Recommendations for Special Management Area (SMA) Use Permit (Major) to Replace Hanohano Hale's Existing Wastewater Treatment System (2020/SMA-

19 [ZS]), 53-549 Kamehameha Highway, Hauula, Oahu, Hawaii.

MISC. COM. 2

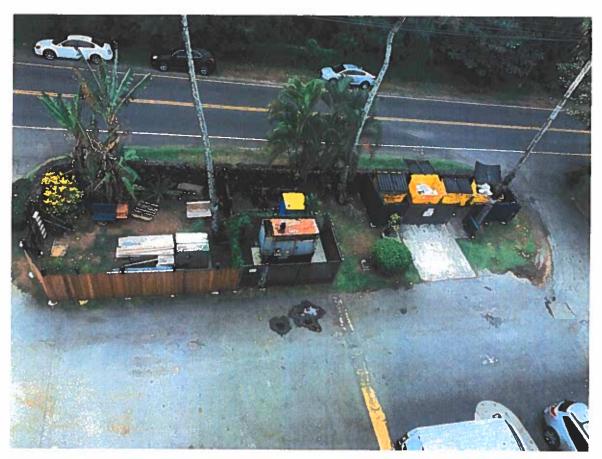
DPP proposed an alternate location for the aboveground system in front of the west end of the building, where the view to the ocean is already obstructed by the building. This location currently contains an electrical transformer, emergency generator, and trash enclosure (see photo below). The ingress/egress driveways are on both sides of this area.

This location is not feasible due to the following reasons:

- 1. Temporary restriction of access path during construction of the wastewater treatment system and regular maintenance of the system.
- 2. Odor risk is increased to residents (closer to building) during maintenance and normal operations.
- 3. Relocation or demolition of existing emergency generator.
- 4. Relocation of existing transformer.
- 5. Removal/relocation of several existing trees.
- 6. Rerouting of Fire Department Connection lines that supply the fire suppression system.

- 7. Rerouting of existing conduit lines in that area.
- 8. Rerouting of existing 3" water line, risk of cross contamination.
- 9. Relocation of trash enclosures and portable toilet.
